Part Number:	FG6338		
Description:	Pan, ADA Roll In, 37-3/4" x 63-1/2", Trench Drain, w/ Cover		
Date Drawn:	03/26/13	Weight:	Scale: None
Drawn By:	Carlos Hernandez	Revised By:	
Approved By:		Date Revised:

**SECTION A-A DETAIL 2**

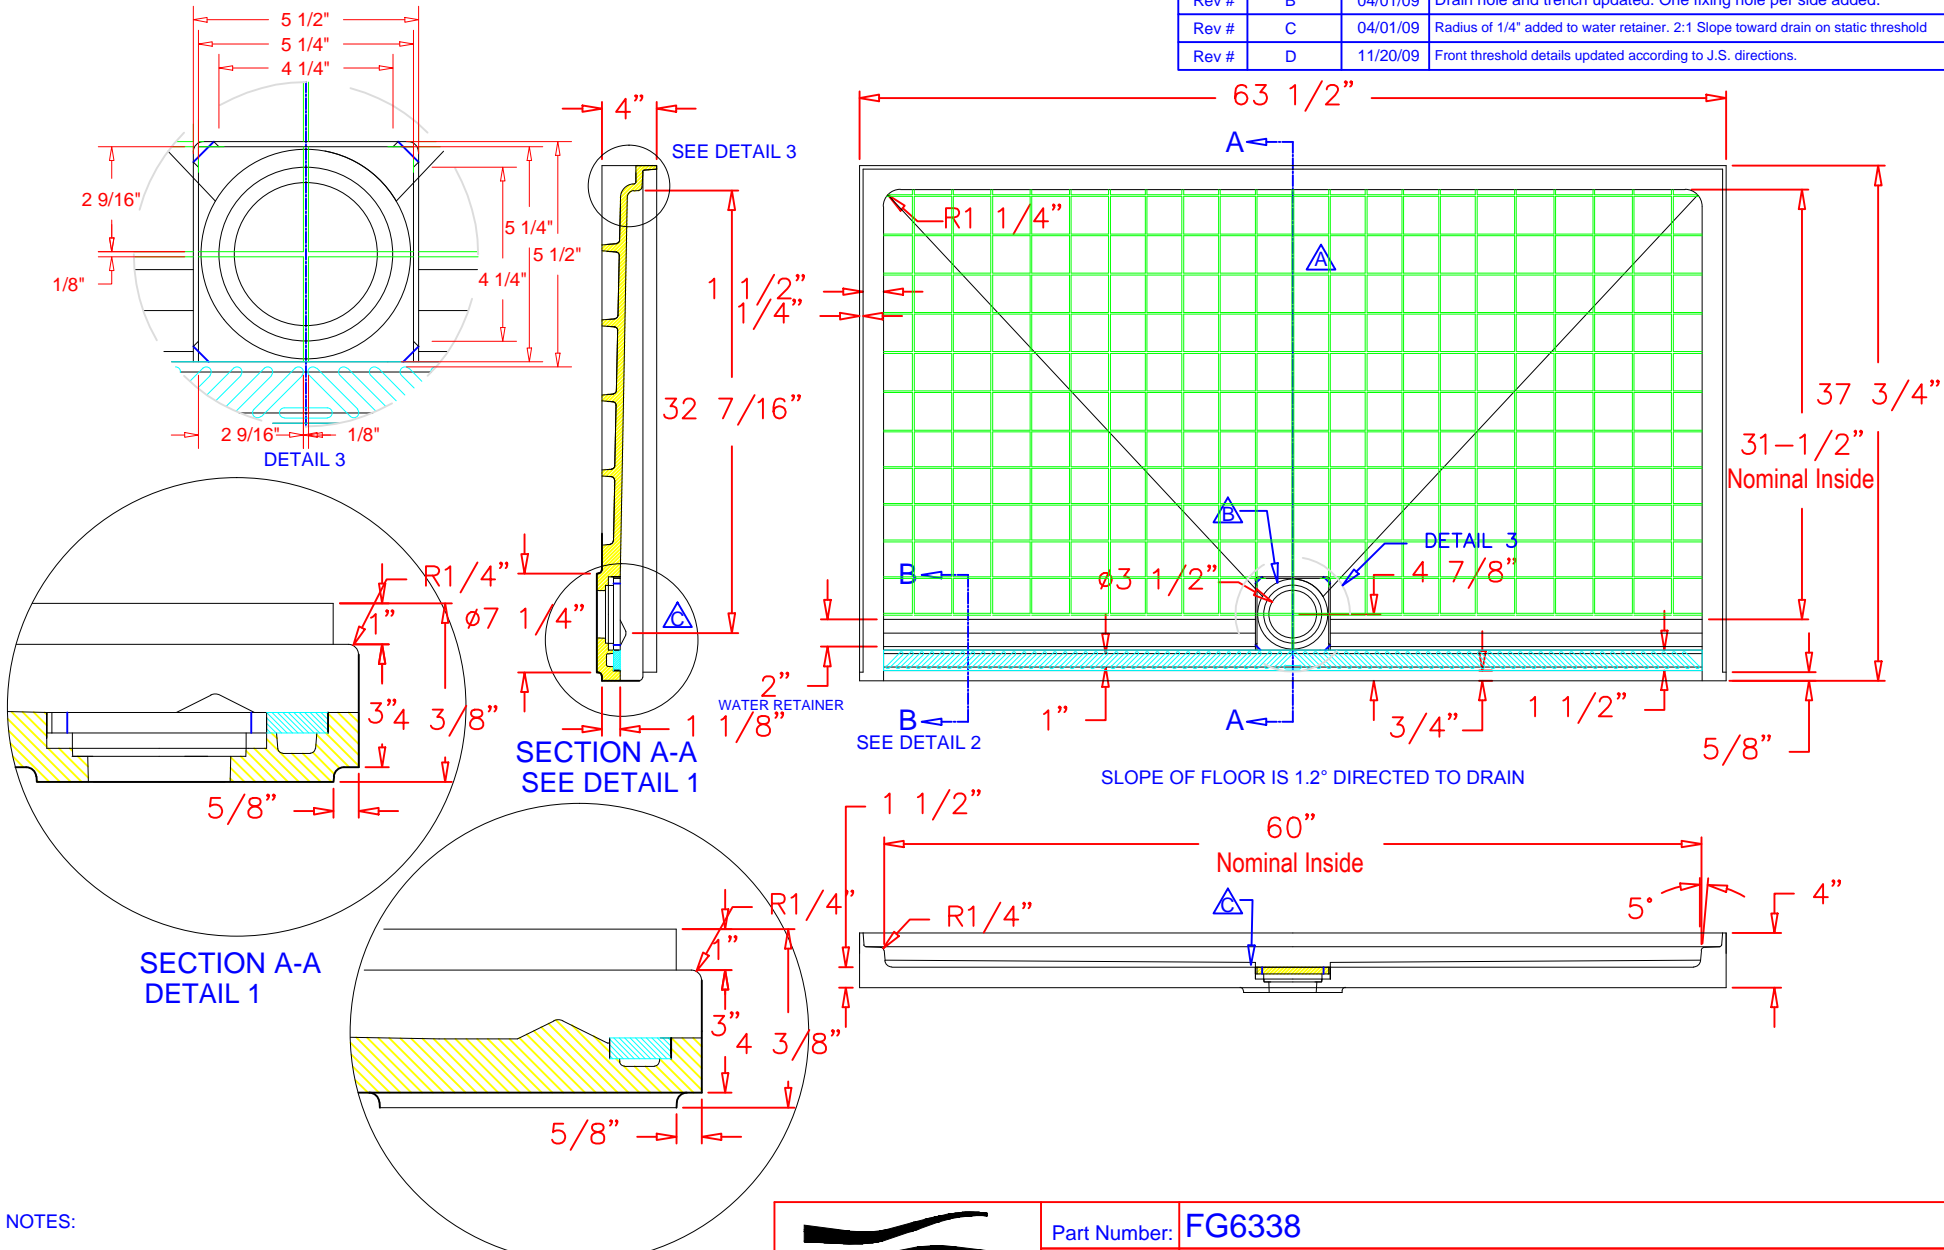
Rev #	A	03/24/09	Distance between reinforcement ribs changed from 10" to 8"
Rev #	B	04/01/09	Drain hole and trench updated. One fixing hole per side added.
Rev #	C	04/01/09	Radius of 1/4" added to water retainer. 2:1 Slope toward drain on static threshold
Rev #	D	11/20/09	Front threshold details updated according to J.S. directions.
